From: Max Yeh <maxwyeh@gmail.com>
Sent: Tuesday, March 26, 2024 4:14 PM
To: pbscommissions
Subject: Comment on U-2023-0004
Attachments: Final Third Comment.pdf

Date: March 26, 2024
Re: Case U_2023-0004
Mendocino Unified School District
Coastal Development Use Permit
Third Public Comment

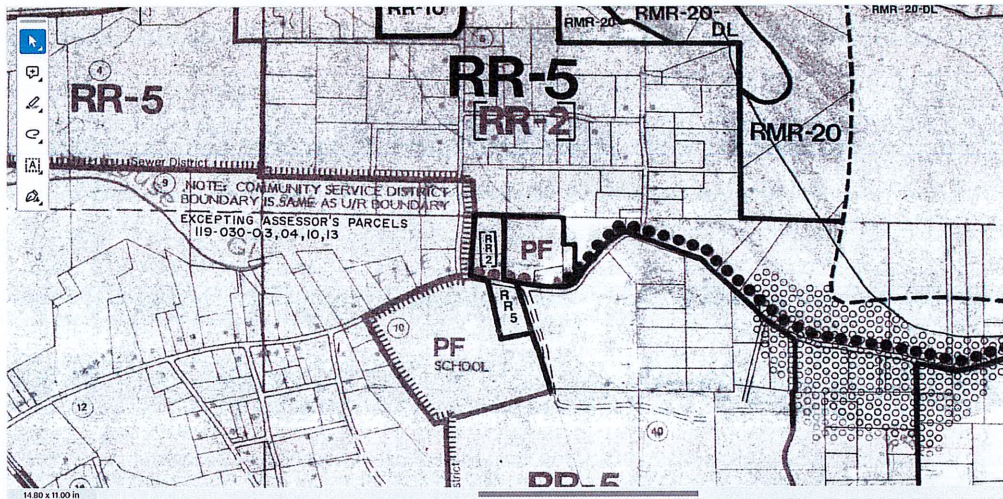
Furthermore, the Little Lake Road at the project site is marked on Coastal Zone Map 17 as scenic; although the Staff Report states (PC-5): “The project site is not mapped as a Highly Scenic Area.” See the following excerpt from Map 17:

At the center of the image the zone marked PF is the project site, across Little Lake Road from the K-8 School, also zoned PF. Highway 1 is at the lower left corner of the image. Little Lake Road going past the project site is marked with the same access dots as mark the bluffs of the Headlands in Mendocino village. This is the designated Little Lake Road Trail.

Recognizing the designation should lead the Staff Report to revise its review of how access trails and scenic views might be impacted. The proposed new tanks will exceed the County's 35-foot building height limit by 13 feet only a few yards from the designated trail. In fact, the tanks will be about as tall as the County Courthouse in downtown Ukiah. The proposed tree trimming will hardly mitigate the aesthetic effect. The Staff Report advises the Commission to waive the height limit because building broader, shorter tanks would disturb more ground. PC-4. I hope the Commission recognizes this "public interest" reasoning as specious. It makes a mockery of height restrictions in general since it can be used to justify any and all high-rises in the Coastal district.
